Accessibility Review Report – DA Review

Project Title: IC3 West Data Centre
17-23 Talavera Road, Macquarie Park

Date: 21 October 2022

Report Version: 21302_ADR_DA_v1.3

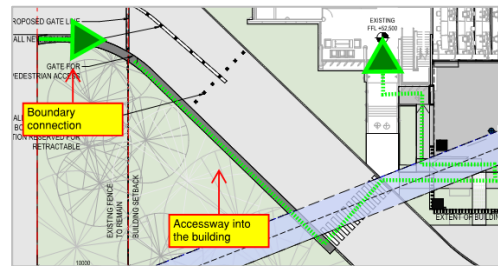
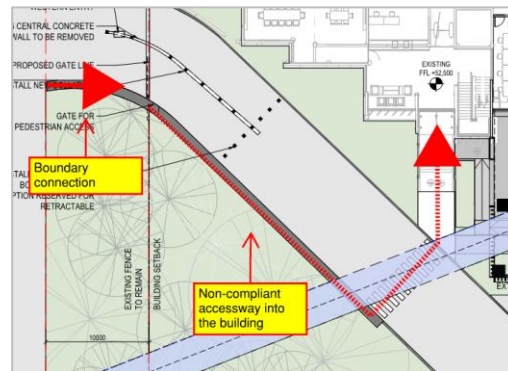
DtS Provision	Comment(s)/Recommendation(s)	Status
<p>An accessway must be provided to a building required to be accessible –</p> <ul style="list-style-type: none"> from the main points of pedestrian entry at the allotment boundary; and 	<p>The following pathway is proposed –</p> <ul style="list-style-type: none"> 1x main point of pedestrian entrance to the building from Talavera Road indicated by a green arrow below. 	DD

Dotted green line indicates the path of travel to the Principal Pedestrian Entry (PPE) from the boundary.

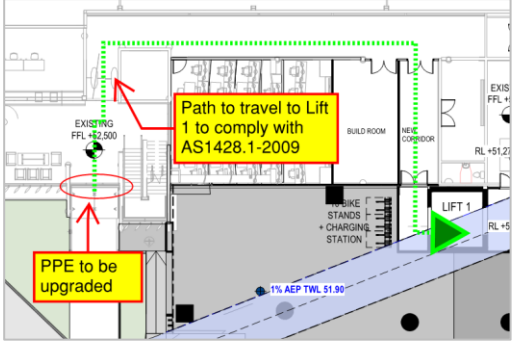
A compliant accessway (existing footpath) is not provided from the main point of pedestrian entrance at the allotment boundary to the building and via the Principal Pedestrian Entry (PPE) indicated by the red arrows below –

- The proposed compliance departure is proposed to be addressed via a Performance Solution. This is to be determined on a case-by-case basis and will require further development / discussion at the detailed design stage.

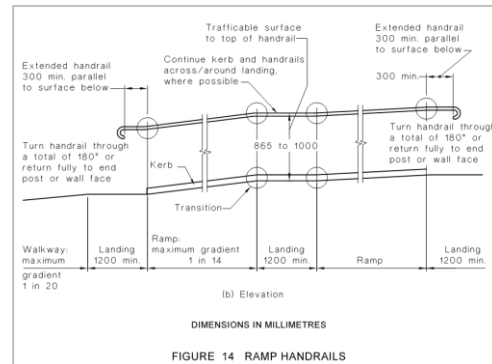
The accessway via the Principal Pedestrian Entry to the new passenger lift (Lift 1) is required to comply with BCA and AS1428.1-2009 due to the “affected part” provisions in the Premises Standard. An audit will need to be completed to verify compliance and address the following key issues:

<ul style="list-style-type: none"> • Access via the PPE (i.e. doorway design/details, door hardware, visual indicators etc.). • Access through the existing security gates (gate width and card reader locations). • Access via the existing corridors and doorways leading to the new passenger lift. <p>Refer to “affected part” in green below:</p>  <p>The following will need to be detailed at the design development stage:</p> <ul style="list-style-type: none"> • Ensure access via the PPE complies with AS1428.1-2009. • Access via the security gates is to allow for a compliant 1m path of travel and swipe card readers at the prescribed locations. • Doorways to achieve an 850mm clear opening width and circulation as prescribed by AS1428.1-2009. • Doorway design including hardware, opening force and contrast to comply with AS1428.1-2009. • Travel (i.e. circulation, floor finishes etc.) via the existing corridors and doorways to comply with AS1428.1-2009.

Level 1B and Levels 2-5 – refer to markup below.

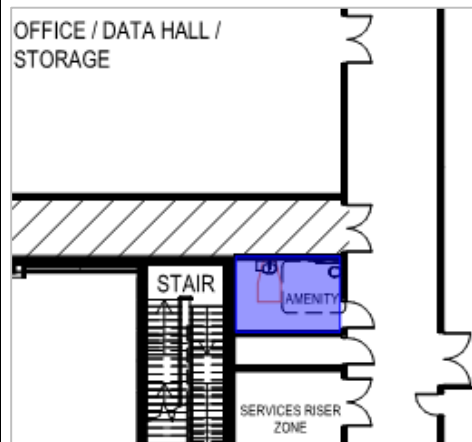
DtS Provision	Comment(s)/Recommendation(s)	Status
In a building required to be accessible:	New accessible unisex sanitary facilities are provided within the lift lobbies on	DD

WCs provided within the accessible unisex sanitary facilities are required to accommodate an equal split between right and left side WC transfers (as evenly as possible). **Currently, facilities have been detailed as RH transfer facilities. This will need to be addressed at the DD stage of the project.**

Design details/fixtures and fittings are to be specified at the Detailed Design Stage.
